Docket Item # 4
BAR CASE #2010-0282

BAR Meeting
October 20, 2010

ISSUE: Alterations (Window Replacement)
APPLICANT: John Murphy by Old Town Windows and Doors
LOCATION: 622 South Lee Street
ZONE: RM / Residential

Figure 4. Window Details

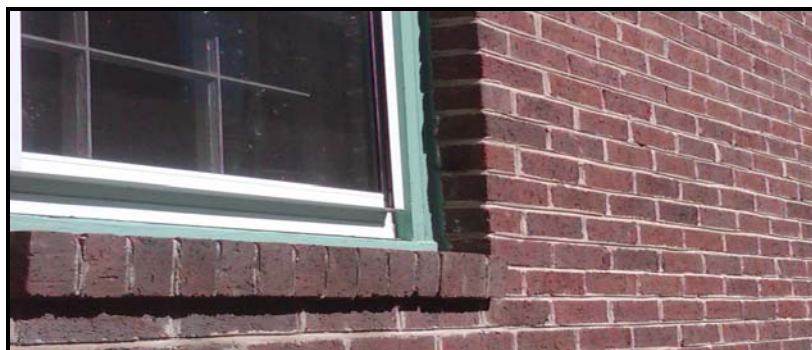
The applicant is proposing to replace a total of six windows; four on the side elevation and two on the rear elevation. The existing windows are single-glazed, double-hung, six-over-six and eight-over-eight wood windows with exterior storm windows. The applicant is requesting approval of Marvin Ultimate, painted wood, double-glazed full-frame replacement windows. The proposed windows will be simulated divided light with an interior spacer bar (dark in color), and an identical light pattern to the windows they are replacing. The 7/8" wood muntins will have a faux putty glaze profile.

Therefore, given the age of the townhouse and the fact that the existing light pattern and putty glazed muntin profile and size of the window will be retained, Staff does not object to the installation of double-glazed wood windows, with simulated divided lights. Staff finds the proposed replacement

Figure 6. Proposed replacement window specifications

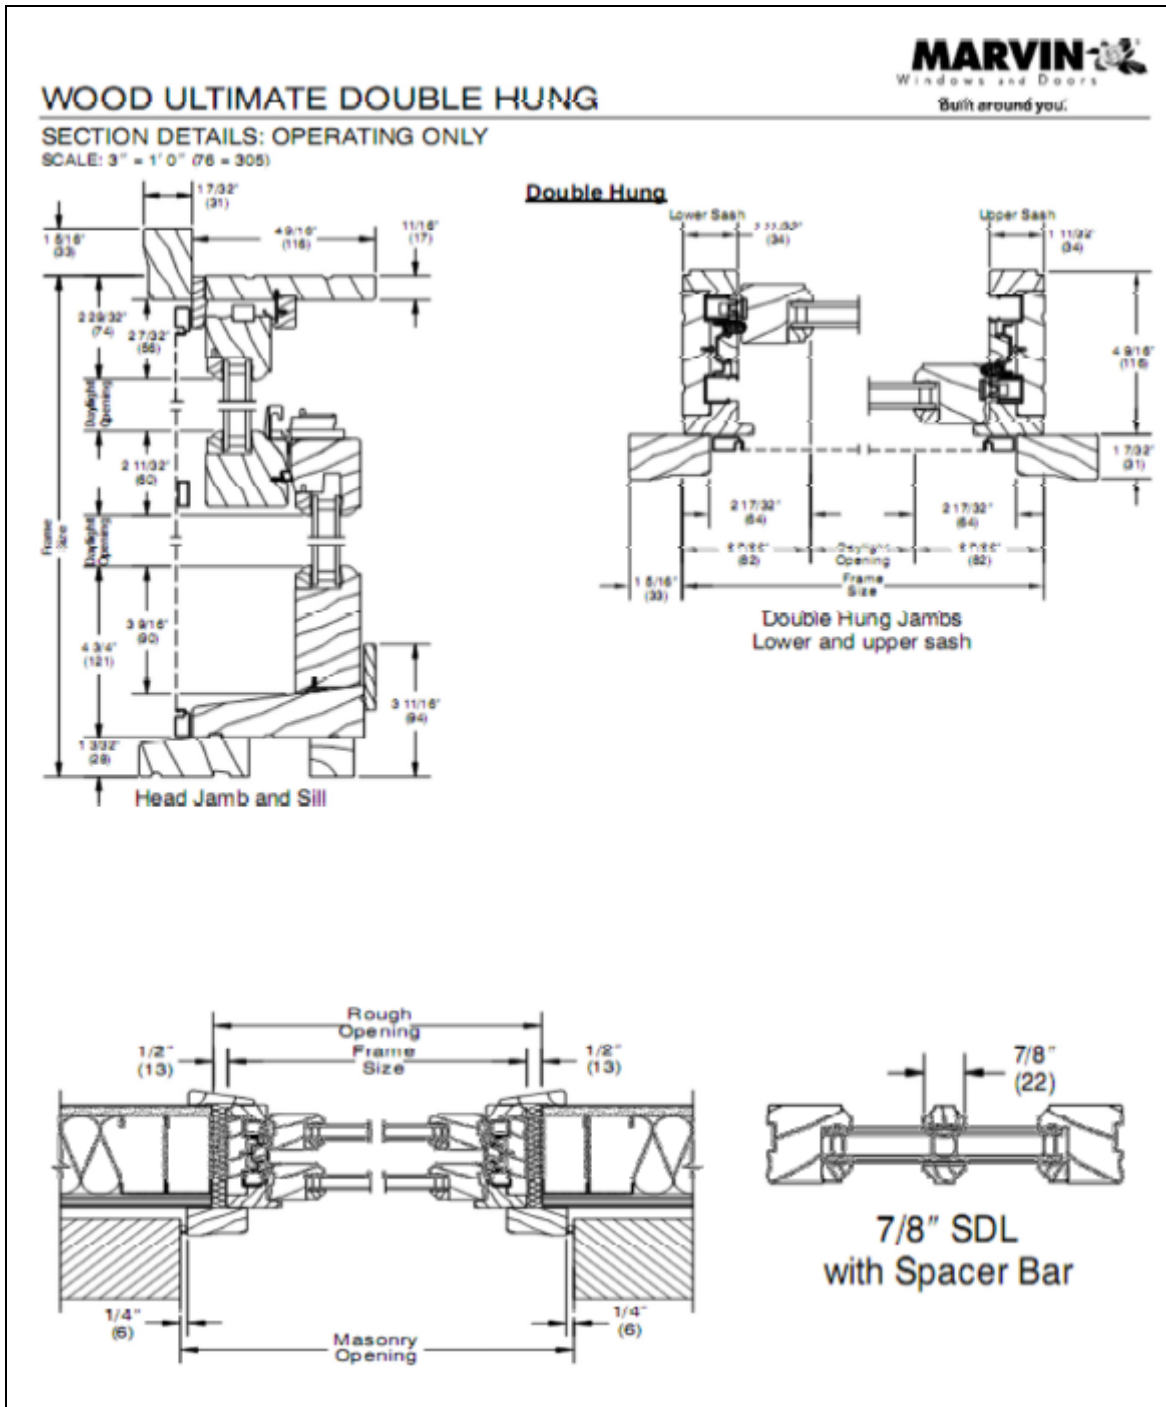
Staff evaluates each proposed replacement window against the draft *Alexandria Window Performance Specifications*. The windows proposed by the applicant appear to meet these specifications.
